IEEE Std C37.90.1™-2002

Correction to: IEEE Standard for Surge Withstand Capability (SWC) Tests for Relays and Relay Systems Associated with Electric Power Apparatus

Correction Sheet Issued

28 June 2004

Figure 1—Oscillatory test waveform

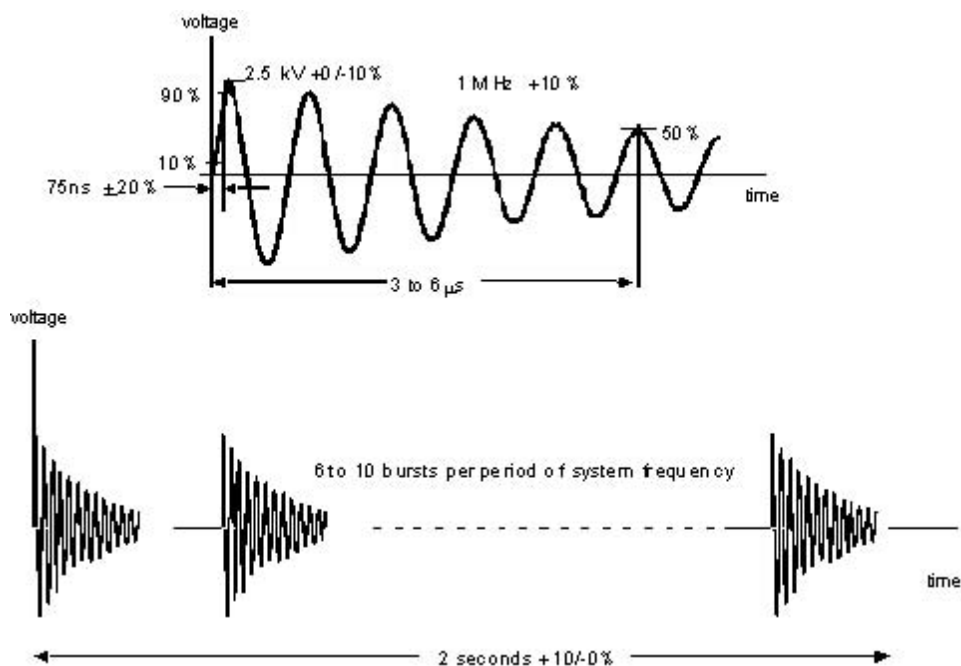
Figure 1 is not consistent with subclause 4.1a in respect to the rate at which the waveform envelope decays to 50% of peak value. Figure 1 should indicate a decay within 3-6 μs , not 4-6 μs . The corrected figure follows.
